February 11, 2003

RE: January 2003 Progress Report
Giant Refining Co., Ciniza Refinery GW-032 Discharge Plan

12/10/02 Meeting held with Giant-Ciniza: GW-032 Dorinda Mancini, Ed Riege, LWP, RCA, Dave Cobrain.

Figure No. 2
Refinery Site Map
Unconfined Storm Water Flow Direction

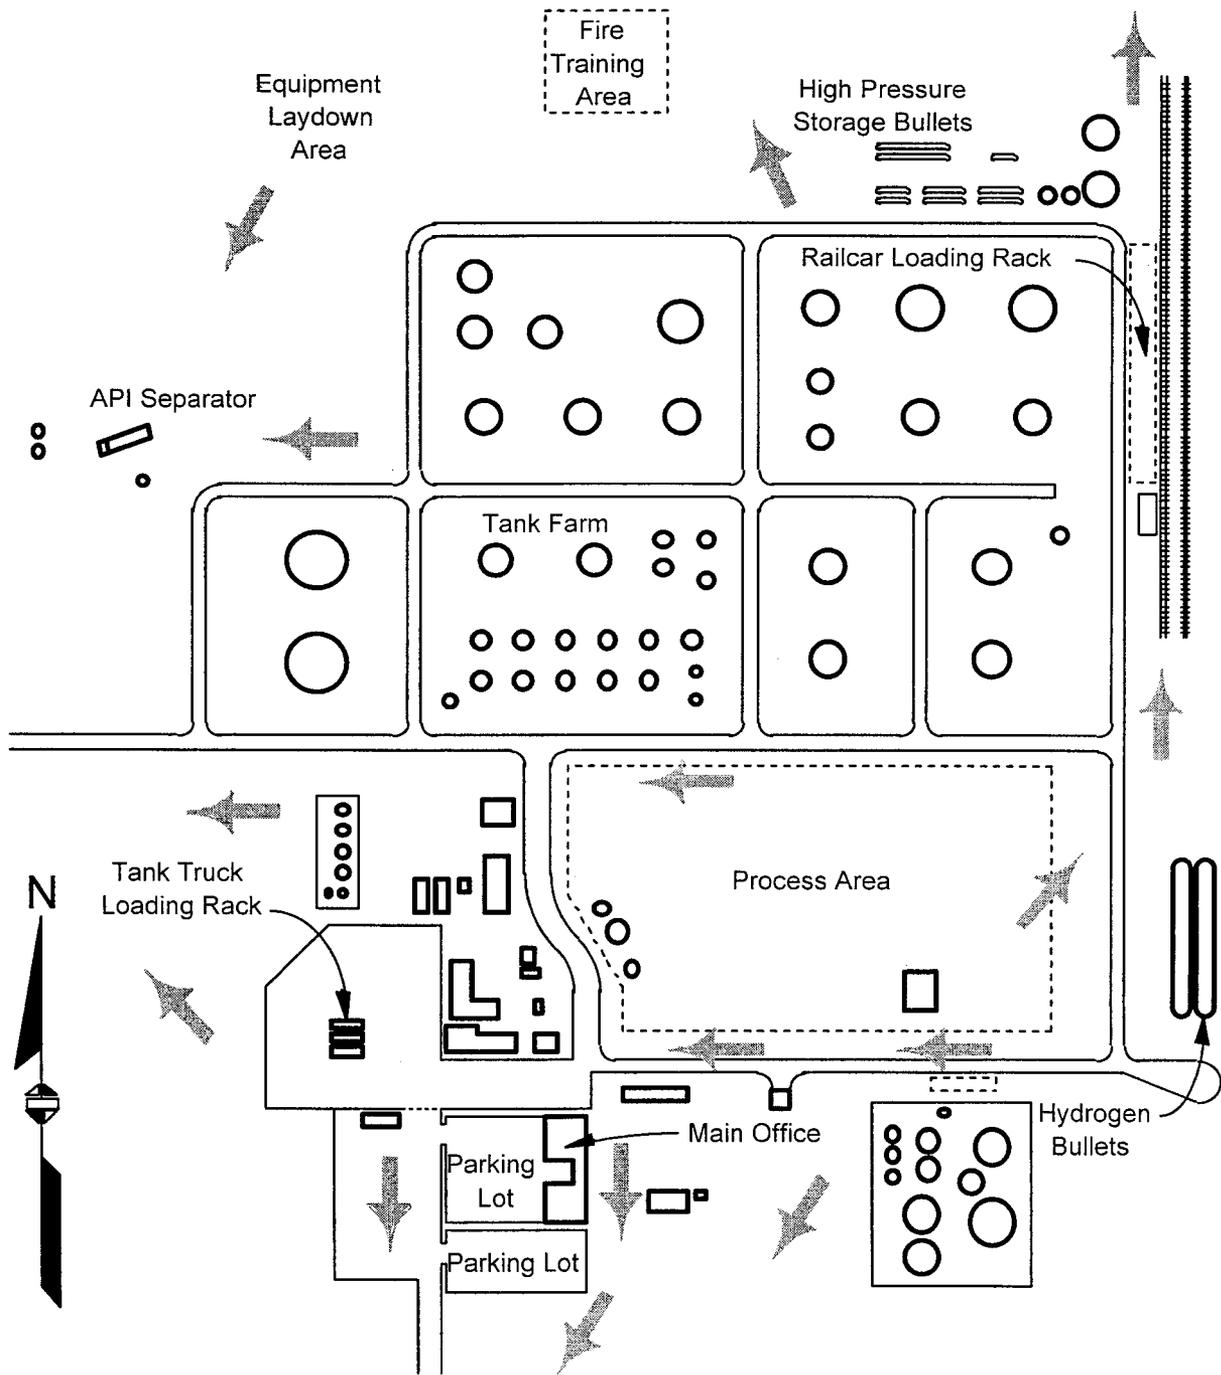
1. Three additional nested wells around ponds - Bill Kingsley, of Precision Engineering, Inc., visited the refinery on 1/29/03 to discuss and locate 3 potential sites on the north and west perimeter of the site. A map of the locations was faxed to you, but we were not able to discuss these with you at the time. Bill will put together a packet containing costs, time requirements, well construction details and any other pertinent information. We will include it in next month's report. He believes that these areas will give us the greatest probability of finding water. As soon as the new wells at the appropriate depths are producing, we would like to close OW-2 and OW-3. We have submitted details previously about the poor construction and production from these wells. Closing the wells on the same trip will save Giant a significant amount over having to schedule and mobilize Precision Engineering a second time for the well closings. Bill feels that the new wells will provide better monitoring for the groundwater in this area. Giant will notify OCD and HWB prior to drilling so that you will have time to schedule a site visit. (Dark blue dots on the map.)

2. Investigate tank farm area near recovery wells and install possible French drain - Bill Kingsley has logs from borings in the areas of both tank farm sites where recovery wells are located. These will be sent in one of the monthly progress reports. Please see the enclosed site map and tank farm maps for more information. Some of the borings are north of and outside the tank farm berms. (Circled in red on the map.)

3. Investigate around old OW-20 high pH area - Again, Bill will provide boring data from the area where OW-20 was located. We made several attempts to drill another well in the same area, but encountered no water. The site map indicates both the old and new OW-20 locations. (Circled in orange on the map.)

4. Investigate past OW-29. Find possible channels – OW-29 has never shown any contamination. We are unclear why this area may need to be investigated. We believe that OW-14, which has shown very low levels of contaminants, should continue to be monitored annually for volatiles by Method 8260. (Circled in light green on the map.)

11. Giant wants to close OW-2 and OW-3 and replace with new ones – see #1 above (Circled in dark blue on the map.)
12. Giant does not want to monitor OW-1, OW-9, and OW-10. RCA wants these wells to be checked to make sure they are still under artesian conditions – We believe that OW-1 should be monitored annually as part of the groundwater discharge plan conditions, along with the 3 new well locations proposed in #1. OW-9 and OW-10 will be visually checked annually at the same time sampling is done to ensure continued artesian conditions. It may be appropriate to sample these 2 wells at 5-year intervals (i.e., as part of the Discharge Plan renewal). As of 2/6/03 these 3 wells have artesian flow. (Circled in light blue on the map.)

CONTRACTOR:			
CINZA REFINERY	GIANT REFINING CO. A DIVISION OF GIANT INDUSTRIES	CALLUP NEW MEXICO	
GIANT REFINERY TANK FARM PLAN			
DRN. BY: CLM	DATE: 10DEC02	RFE/RFC No: -	
CHK'D. BY: -	DATE: -	SCALE: NTS	
APP'D. BY: -	DATE: -	CAD REF: G/SULLIVAN	
WELD SPEC: -	PANE: -		
DRAWING NO. Z-01-100			REV 0

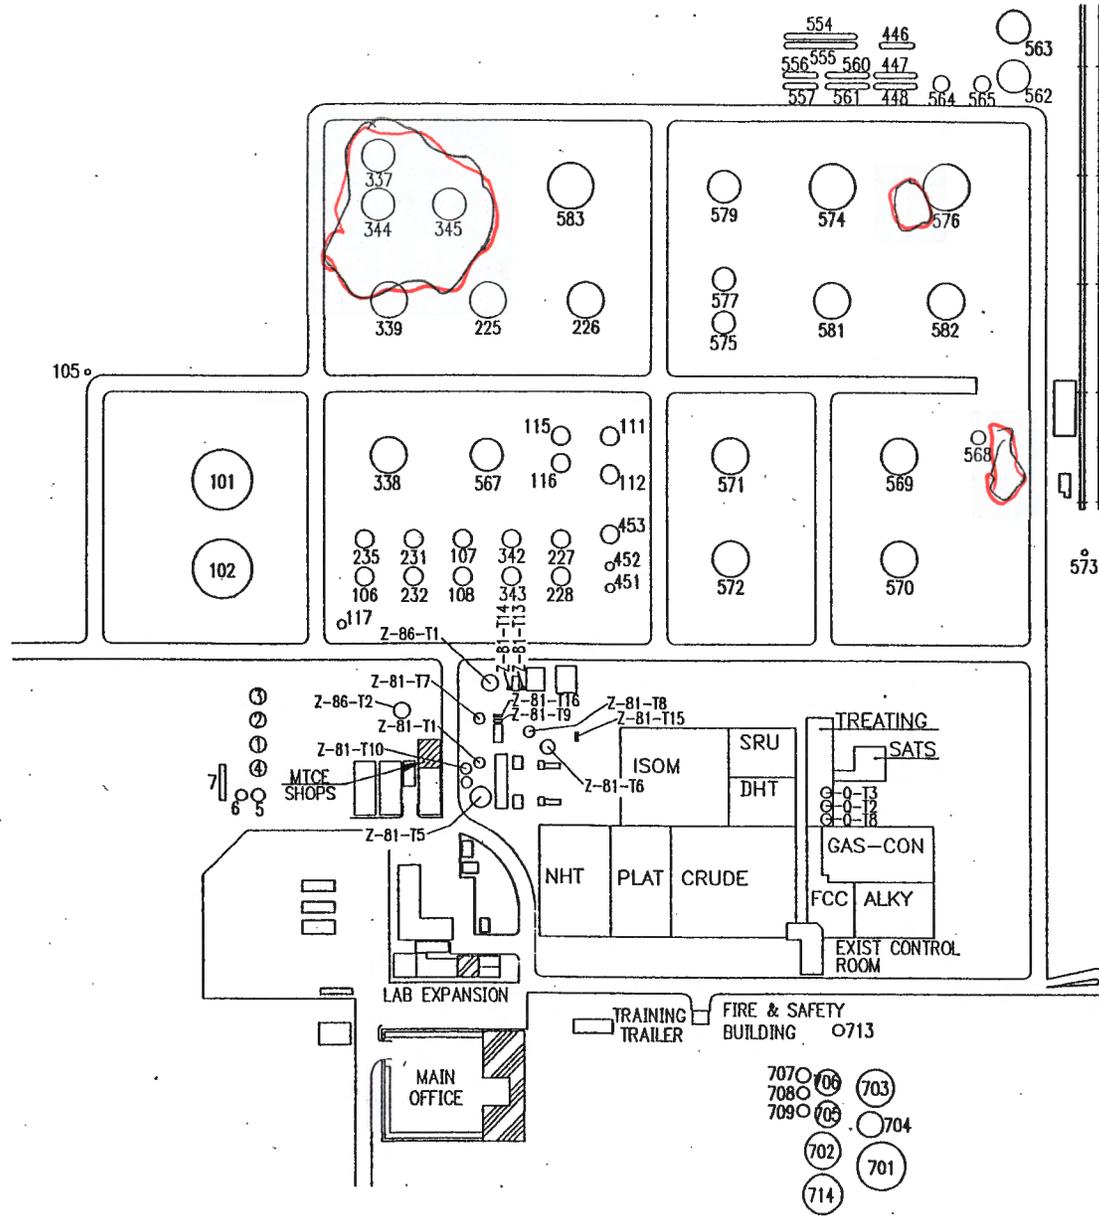
5. Inspect the truck center – Giant's travel center has been notified and is available for inspection at your convenience.
6. Find out where OW-17 was located. Now closed, but was originally located w/in tank farm. Sonsela wells were closed in this area. – Ciniza has submitted this information previously, but will include it again in a future monthly progress report. The site map and tank farm maps are marked to show the area of interest. OW-17 was located near Tank 345. (Circled in red on the map.)
